Clonburris T1

Street Hierarchy, Design & Layout Submission

For Proposed Residential Development
Clonburris T1, Co. Dublin

Compliance Submission in Accordance with
Planning Condition no. 2

Plan of Unnamed Street / Drawing Ref: CLB-1-00-SW-ZZ-DR-CWO-AR-1000

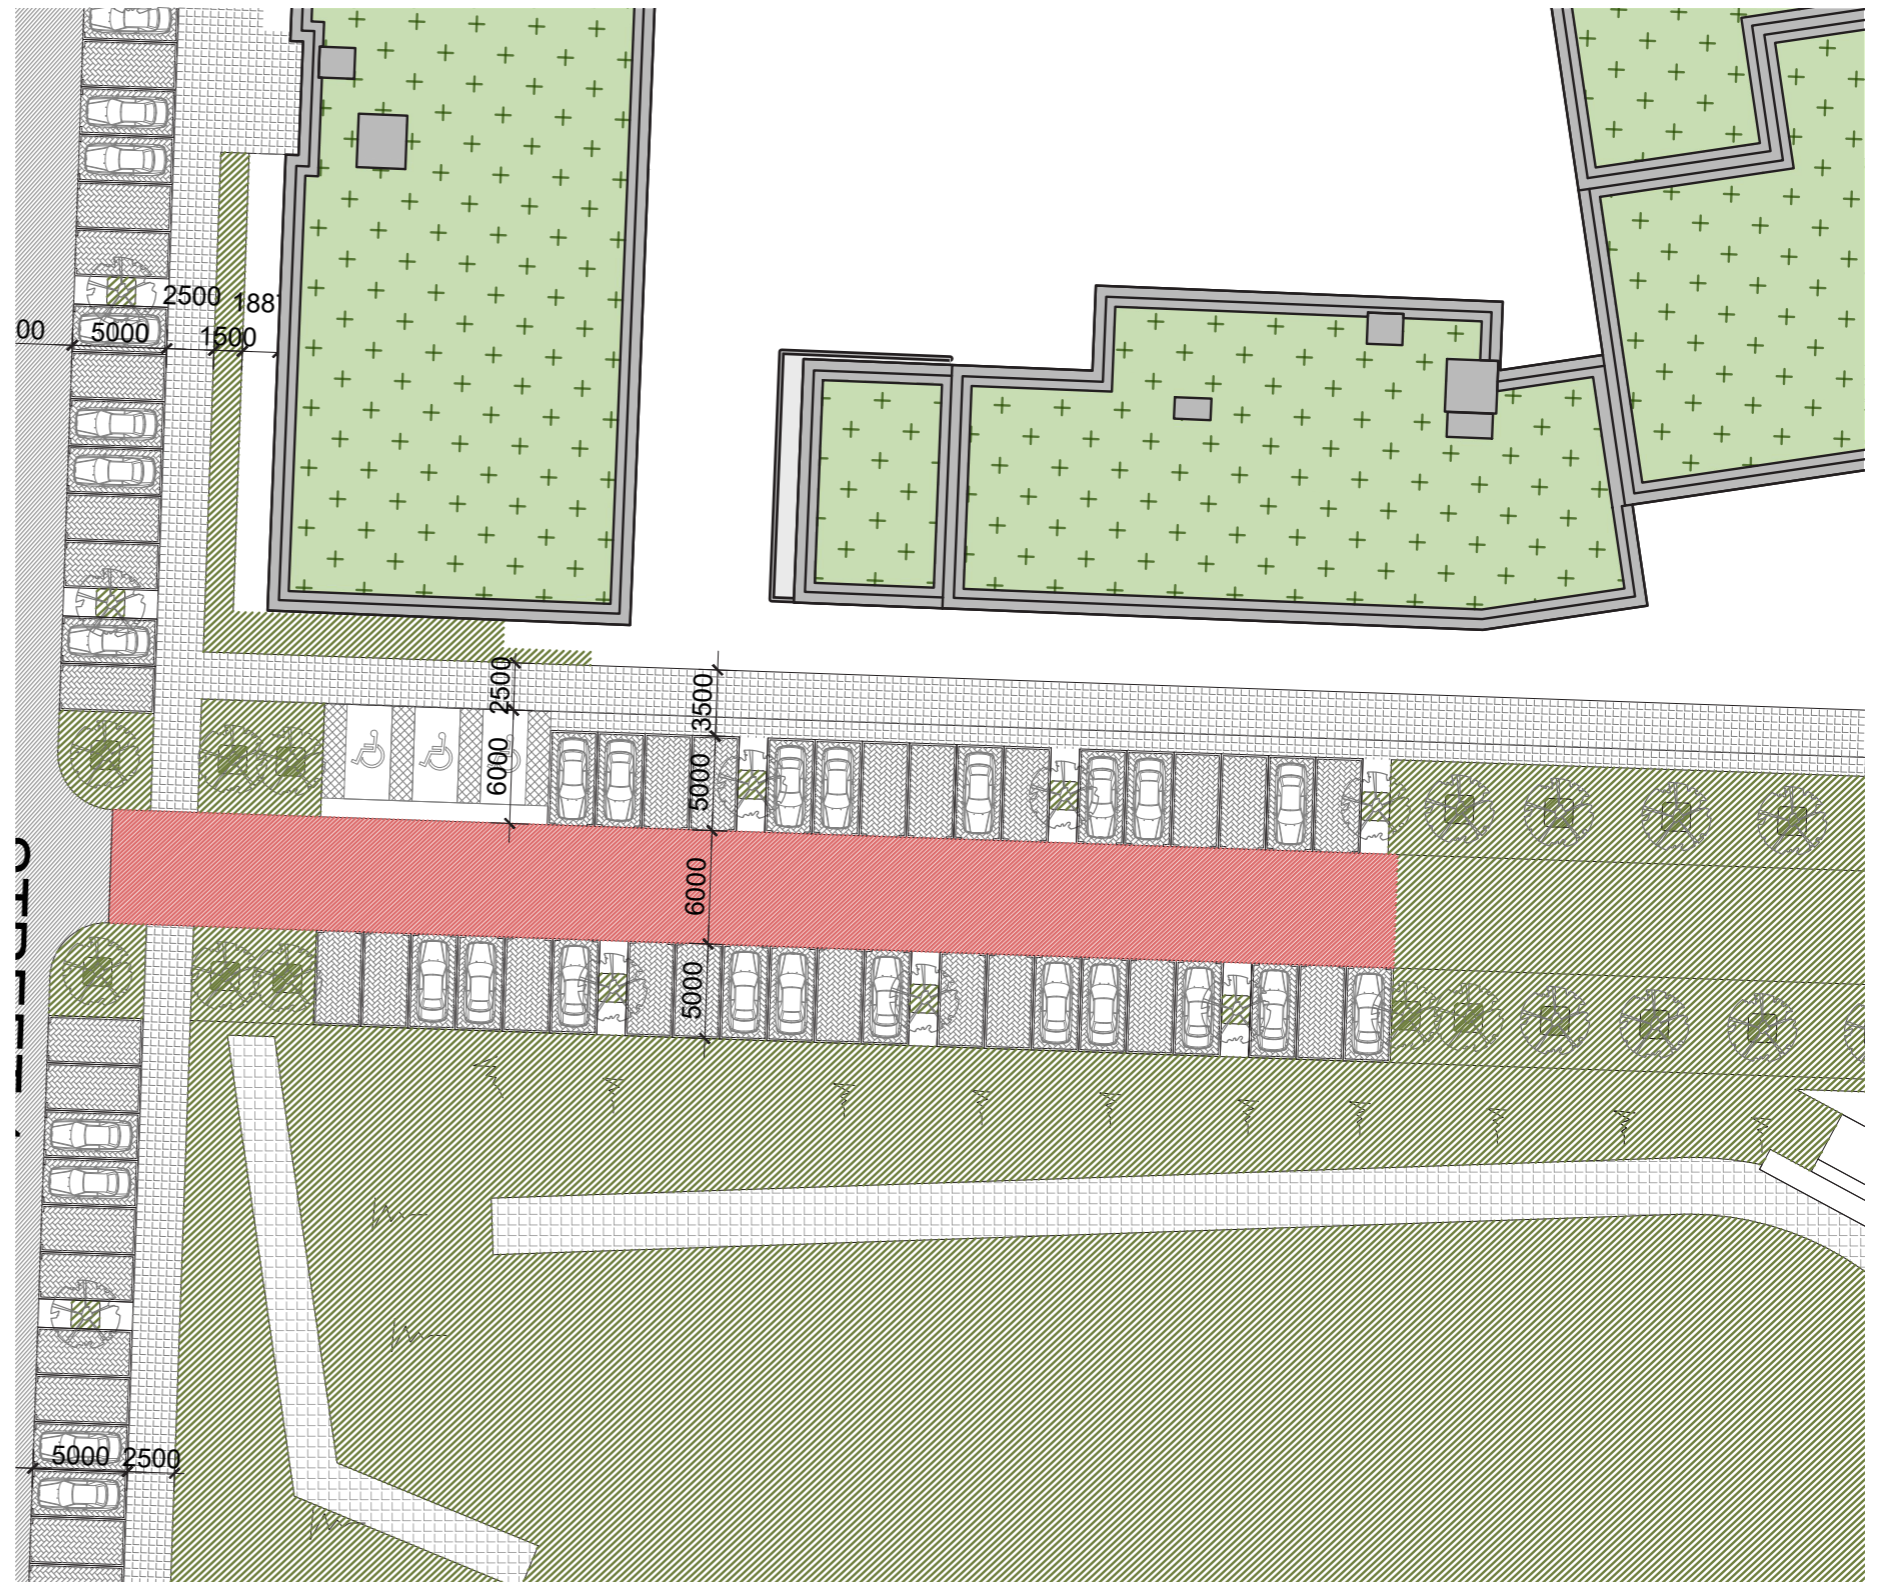
2 (a) The unnamed street, located to the south of Apartment Block 1 shall be redesigned to be fully pedestrianised outside of delivery hours. A parking courtyard may be provided at this location. If a parking court is provided, it shall be restricted in size to no more than 40 spaces and should also be well landscaped and subject to a landscape plan, in accordance with Section 2.8.10 of the Planning Scheme.

This street has been reconfigured to include 40 no. car parking spaces, of which 3 are accessible spaces. The parking courtyard has been landscaped in accordance with Section 2.8.10 of the Planning Scheme. The top area has been landscaped in order to maintain fire tender access for the building. Details of the landscaping are contained in Condition 11 Response.

Plan of Street 1 / Drawing Ref: CLB-1-00-SW-ZZ-DR-CWO-AR-1000

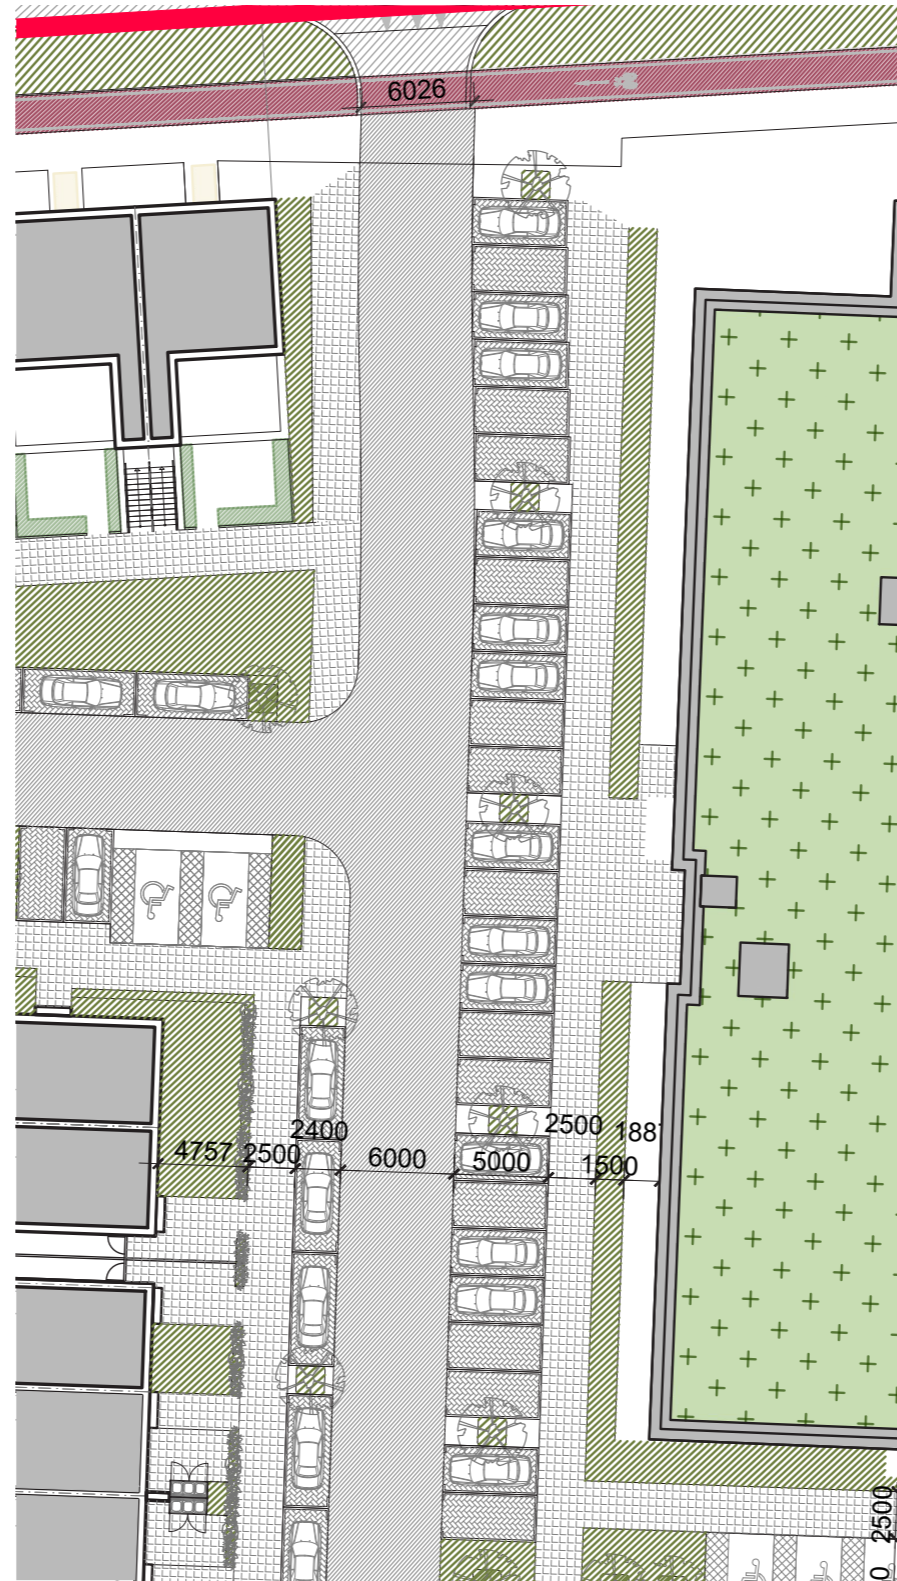
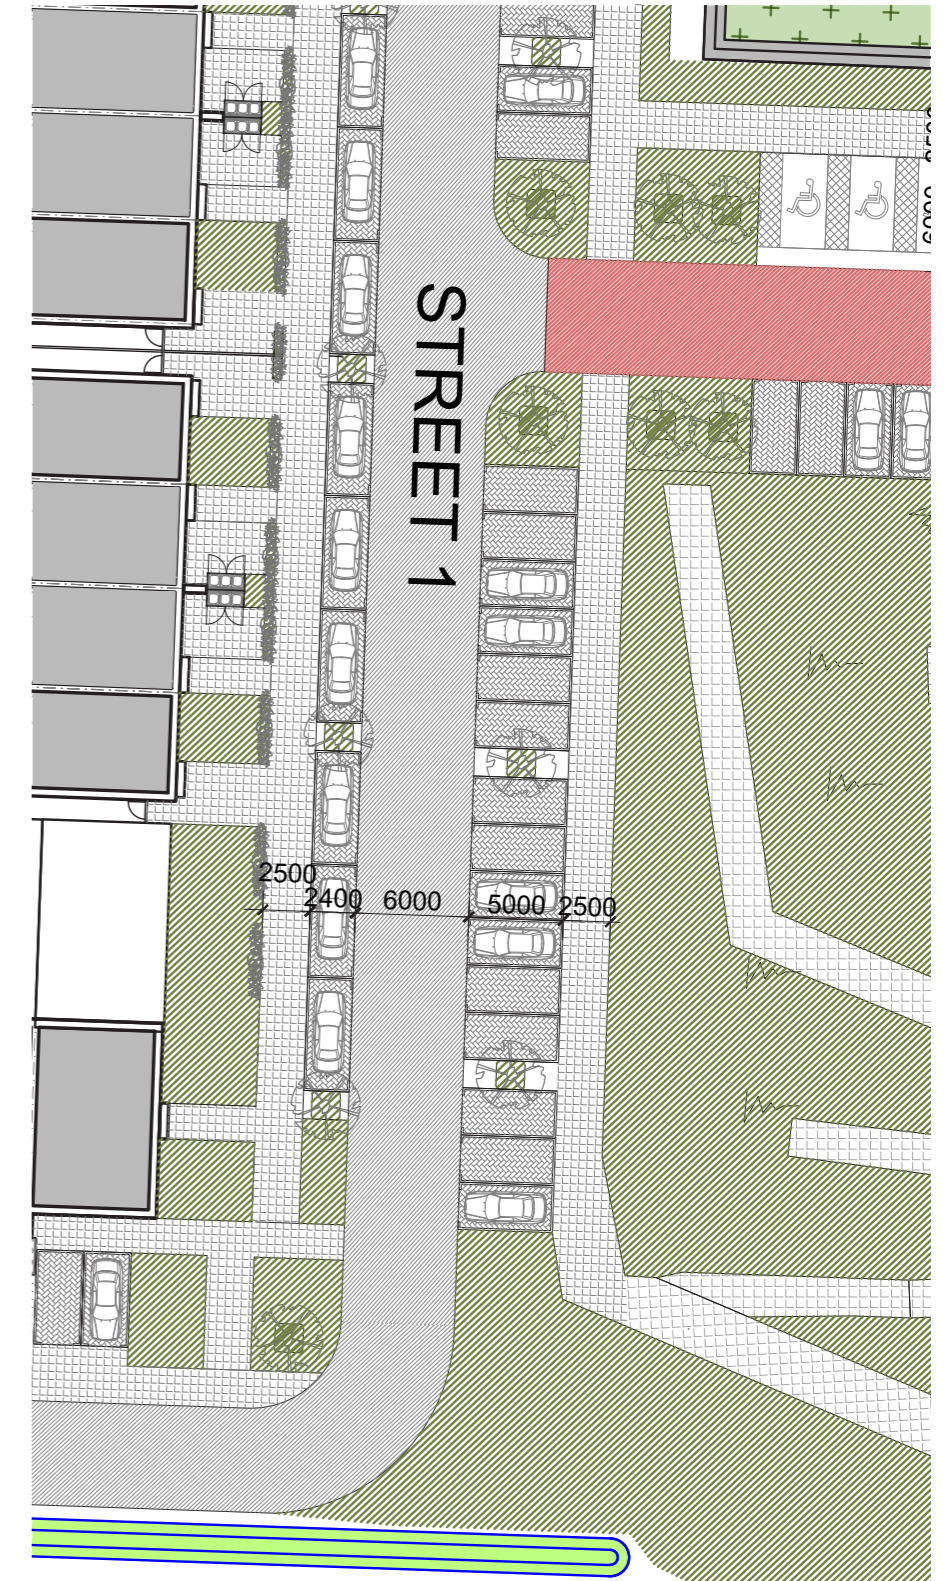
2 (b) Street 1: The street shall be redesigned in general accordance with Figure 2.2.6 Indicative Local Street A. The following detail shall be provided.

- The street shall have a carriageway width of no less than 5 meters and no more than 6 meters; 6m shall be provided for reversing if perpendicular parking is proposed
- Perpendicular parking bays shall be a minimum of 5m deep and parallel shall be a minimum of 2.4m.
- At any point along the road, perpendicular parking shall be provided on one side only;
- A footpath width of between 2.5 and 4 meters shall be provided;
- Privacy strips/short gardens that range from 1 to 3 metres in depth shall be provided
- Street trees shall be provided in accordance with Condition 7

Street 1 has been designed in accordance with Figure 2.2.6 Indicative Local Street A.

- The street has a carriageway width of 6 meters; 6m has been provided for reversing as perpendicular parking is proposed
- Perpendicular parking bays are a minimum of 5m deep and parallel are a minimum of 2.4m.
- Perpendicular parking is provided on one side of the road only;
- A footpath width of 2.5 meters has been provided;
- Privacy strips that range from 1.8 to 4.75 metres in depth shall be provided;
- Street trees have been provided in accordance with Condition 7,.

Plan of Street 3 / Drawing Ref: CLB-1-00-SW-ZZ-DR-CWO-AR-1000

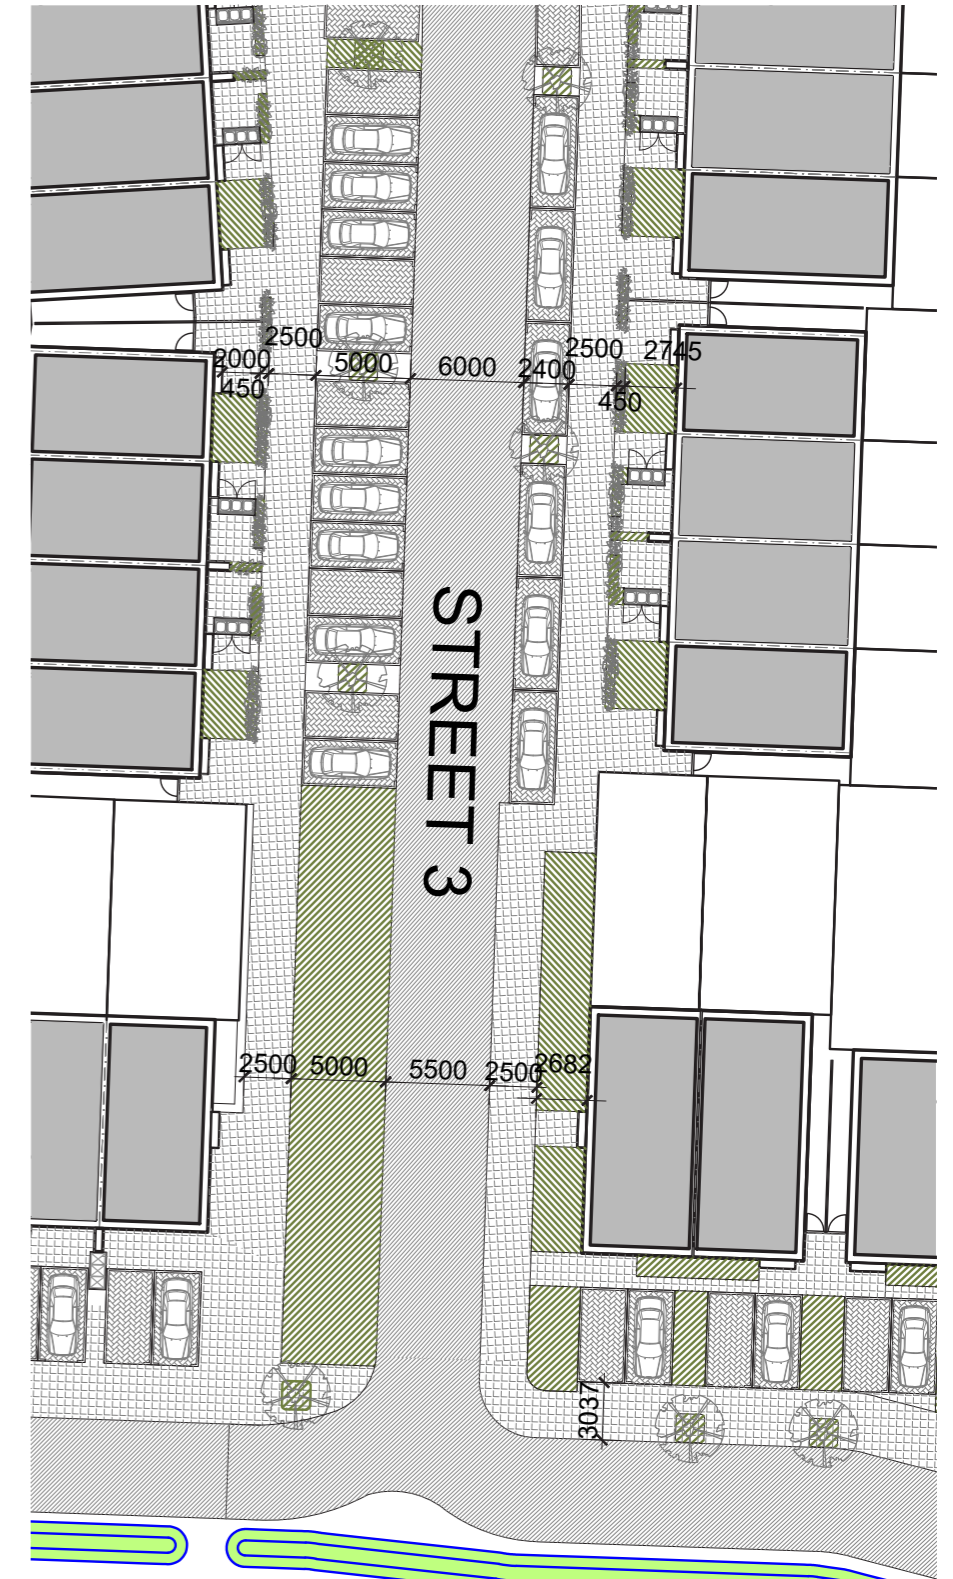
2 (d) Street 3: The street shall be redesigned in general accordance with Figure 2.2.6 Indicative Local Street A. The following detail shall be provided.

- The street shall have a carriageway width of no less than 5 meters and no more than 6 meters; 6m shall be provided for reversing if perpendicular parking is proposed
- Perpendicular parking bays shall be a minimum of 5m deep and parallel shall be a minimum of 2.4m.
- At any point along the road, perpendicular parking shall be provided on one side only;
- A footpath width of between 2.5 and 4 meters shall be provided;
- Privacy strips/short gardens that range from 1 to 3 metres in depth shall be provided
- Street trees shall be provided in accordance with Condition 7

Street 3 has been designed in accordance with Figure 2.2.6 Indicative Local Street A.

- The street has a carriageway width of between 5.5 and 6 meters; 6m has been provided for reversing where perpendicular parking is proposed
- Perpendicular parking bays are a minimum of 5m deep and parallel are a minimum of 2.4m.
- Perpendicular parking is provided on one side of the road only;
- A footpath width of 2.5 meters has been provided;
- Privacy strips that range from 2.6 to 3.2 metres in depth have been provided;
- Street trees have been provided in accordance with Condition 7.
